**Avenal Power Center, LLC  
500 Dallas Street, Level 31  
Houston, TX 77002**

**Re: Avenal Energy, Docket No. 08-AFC-1:  
Response to U.S. Fish and Wildlife Service September 8, 2008 Letter to U.S.  
Environmental Protection Agency, Region 9**

**Avenal Power Center, LLC Response**  
**to Request for Information from the U.S. Fish and Wildlife Service**

FIGURE 2.3-12  
CONSTRUCTION OFFICES  
PARKING AND LAYDOWN AREAS

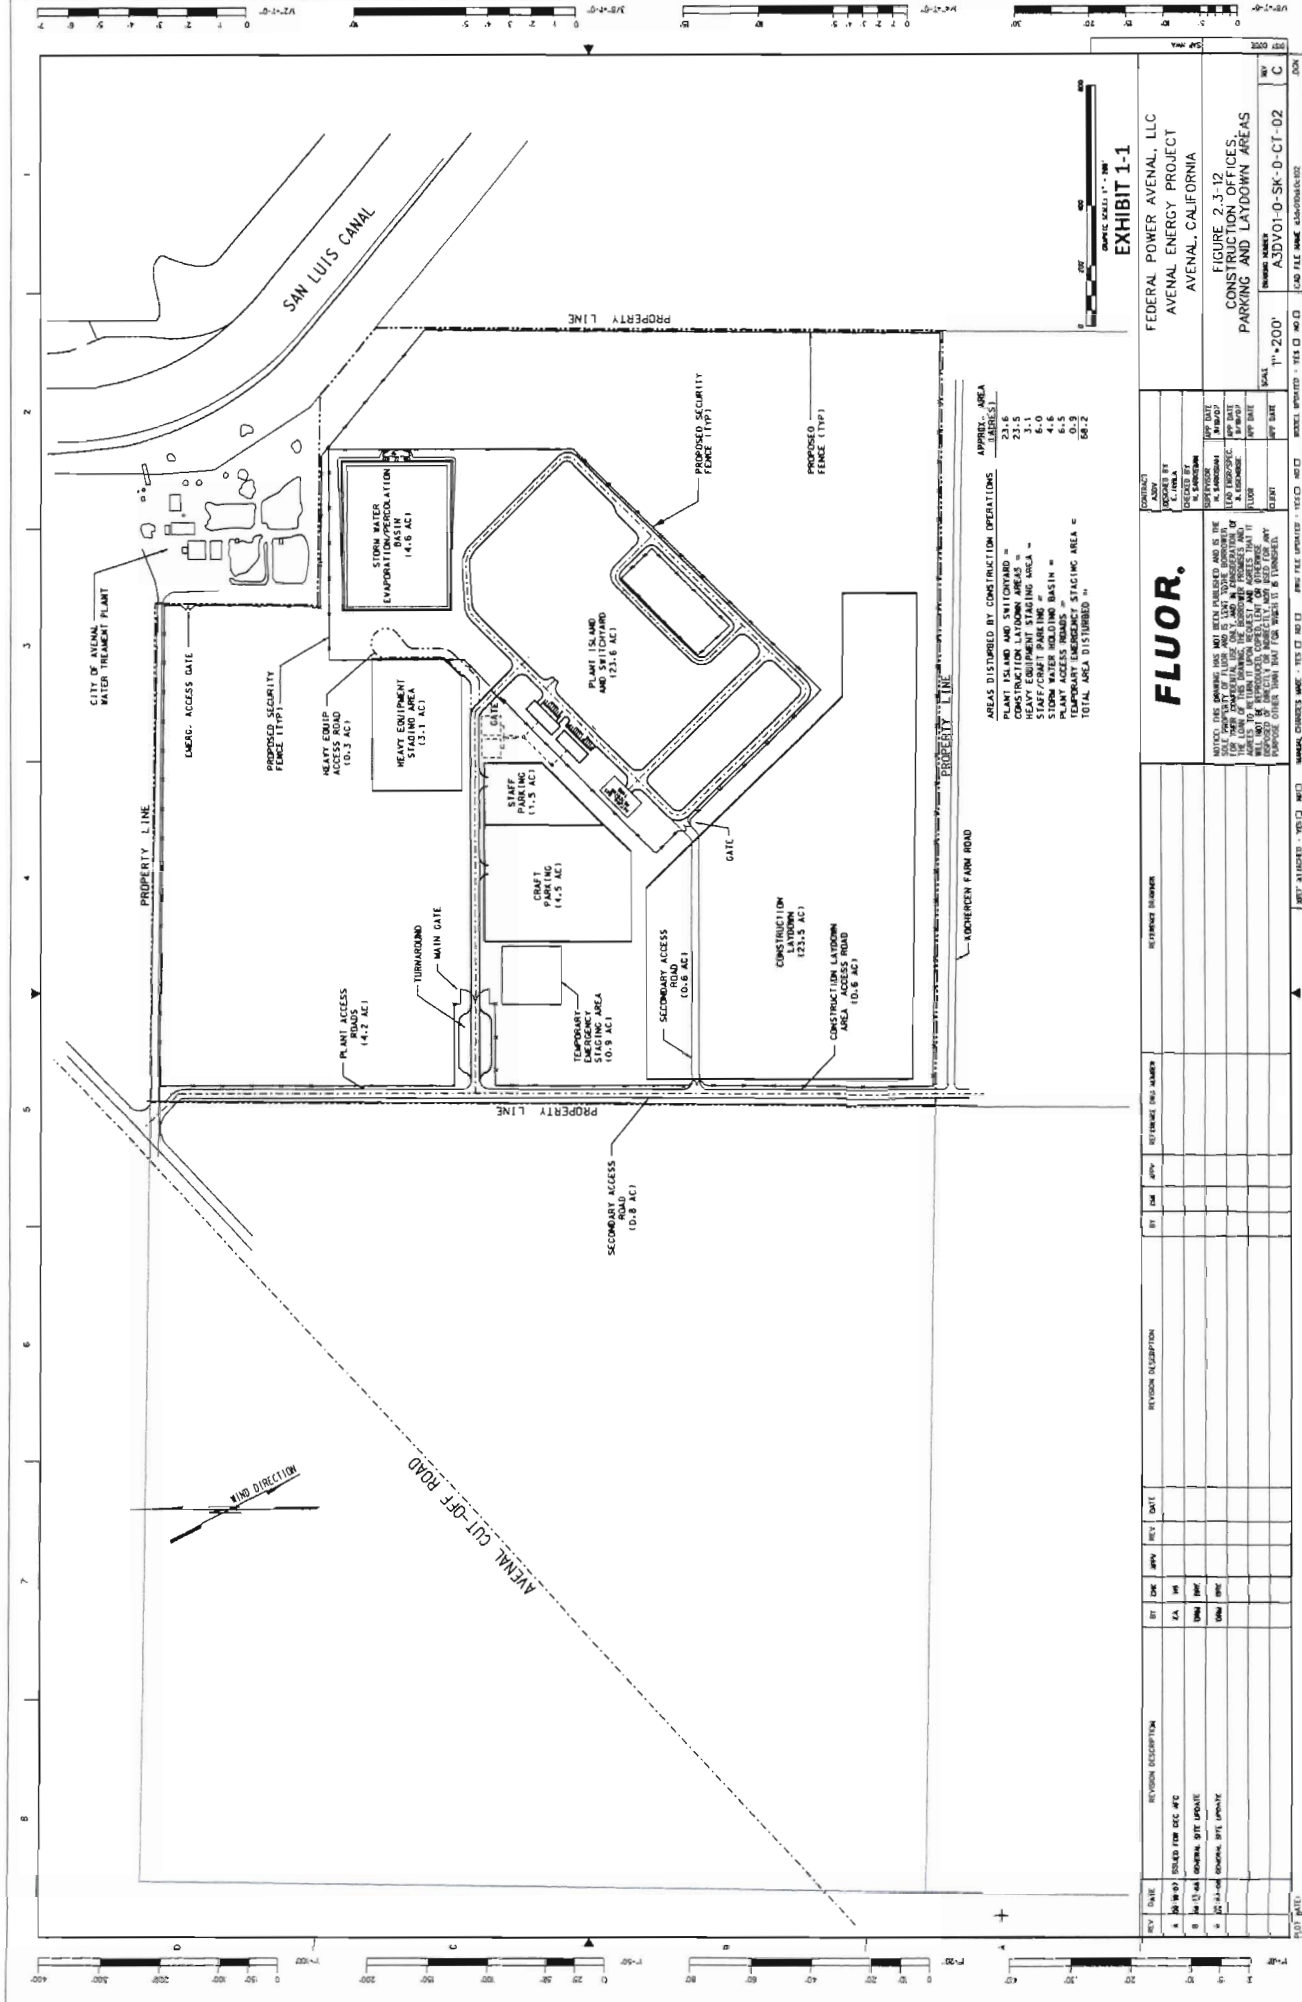
**2) On page 2-50 in section 2.3.18.6 -Mobilization, is a statement that gravel and road base material will be used for 'temporary' roads, laydown, parking and work areas. Per Figure 2.3 12, this totals to 35.25 acres potentially covered in gravel and/or road base materials (24.10 acres construction laydown, 3.05 acres heavy equipment parking, 4.5 acres craft parking, 1.45 acres staff parking, 2.15 acres temporary road access).**

a) How much of this 35.25 acres will remain covered in gravel or road base material once construction is complete?

b) Other than the 35.25 acres so outlined in Figure 2.3-12, will there be any areas not currently included as permanent impacts that will be areas covered in road material or gravel?

**3) On page 2-52, table 2.3-7 gives an estimate of 28 acres temporary disturbance for the construction of the power generation facility. A review of the acreage provided in Figure 2.3-12 suggests these numbers should be 33.1 acres temporary disturbance.**

a) Please provide details of the temporary disturbance calculation for the power generation facility that resolves this discrepancy.

As shown on Exhibit 1-1, permanent fencing will be constructed at the perimeter of the 148-acre parcel, except the perimeter fence will be held back 300 feet from the San Luis Canal (measured from the inside top of the canal embankment). This fencing will consist of 4-foot high wire-strand fencing and is identified as “proposed fence (typ)” on Exhibit 1-1.

An additional permanent Plant security fence will be constructed at the perimeter of the power block area and around the storm water evaporation/percolation basin. This fence is identified as “proposed security fence (typ)” on Exhibit 1-1 and will consist of a grounded seven-foot high chain link fence with one foot of security wire (e.g., razor wire) at the top.

Exhibit 1-1 provides an updated Figure 2.3-12. Gravel will be removed from all of the temporary disturbance areas at the completion of construction, so none of the temporary disturbances will be covered with gravel once construction is complete. A portion of what was formerly identified as the “temporary access roadway” (formerly 2.15 acres) is now designated as a “secondary access road” (including a 0.6 acre segment and a 0.8 acre segment, for a total of 1.4 acres) that will remain in place as an emergency access roadway during operations, per a request from the California Energy Commission. This 1.4 acre area will potentially remain covered in gravel or road base material once construction is complete. This area is now included in the project’s revised permanent (operations) disturbance estimate provided in Exhibit 1-2.

The acres outlined in Figure 2.3-12 provided as Exhibit 1-1 show both temporary and permanent disturbances. The temporary acreage potentially covered in gravel and/or road base materials includes construction laydown (23.5 acres), heavy equipment staging area (3.1 acres), craft parking (4.5 acres), and staff parking (1.5 acres). The secondary access road will stay as an emergency access road during operations and will potentially be covered in gravel and/or road base materials, so the total temporary impacts potentially covered in road material or gravel will total 32.6 acres. Upon

Revised Figure 2.3-12 is provided as Exhibit 1-1. Revised AFC Table 2.3-7 with the disturbed acreage estimates is provided as Exhibit 1-2. The updated temporary disturbance calculation for the construction of the power generation facility is 33.5 acres.
